**CHANGE ORDER NO.: 1**

Owner:	City of Jackson, MO	Owner's Project No.:	n/a
Engineer:	Koehler Engineering	Engineer's Project No.:	38046/38101
Contractor:	CE Contracting, Inc.	Contractor's Project No.:	n/a
Project:	N. Union Street San. Sewer and Lift Station and North Ind. Park San. Sewer Ext.		
Contract Name:	Agreement between City of Jackson, MO and CE Contracting, Inc.		
Date Issued:	January 11, 2022	Effective Date of Change Order:	January 17, 2022

# WORK CHANGE DIRECTIVE NO.: [1]

**WORK CHANGE DIRECTIVE NO.: [2]**

**CIVIL SITE PLAN #1 STATION DETAIL 3**  
DATE: 1/1/2021  
DRAWN BY: J. COLE  
CHECKED BY: J. COLE  
SCALE: 1" = 10'

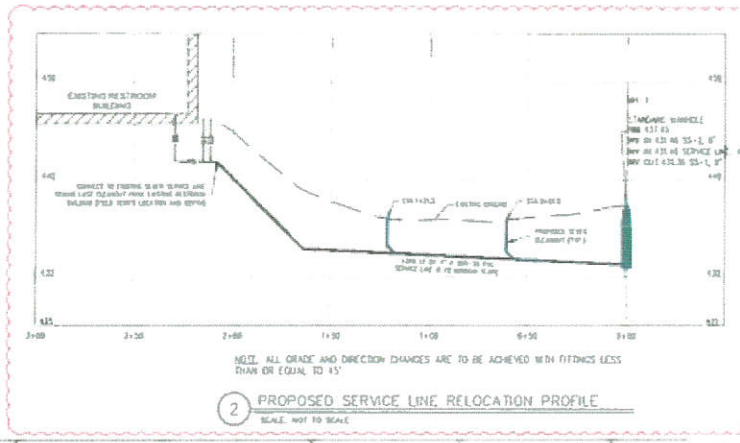
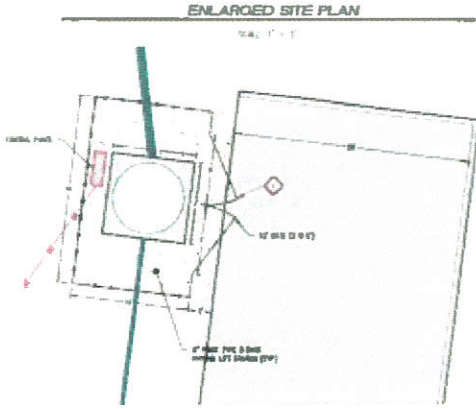
Bid Item #5) Surface Restoration, Seeding, and Mulching – Increase in plan amount as required by the connection of the 2<sup>nd</sup> restroom connection, see Revised Plan Sheet C2.1 attached. Increased amount \$1,370.00

Bid Item #10) Relocate Existing 4" Service Line – Increase in plan amount as required by the connection of the 2<sup>nd</sup> restroom connection, see Revised Plan Sheet C2.1 attached. Increased amount \$4,975.00

Our revised total price for Item #5 is \$5,140 and Item #10 is \$6,285. Total change to contract is \$6,345. That should cover our work for the revised connection to the 4" service line per revised Sht 2.1 dated 8/25/21.

See attached plan sheet updated to include relocation of the existing service line from the restroom east of the proposed lift station on the Union Street sewer project.
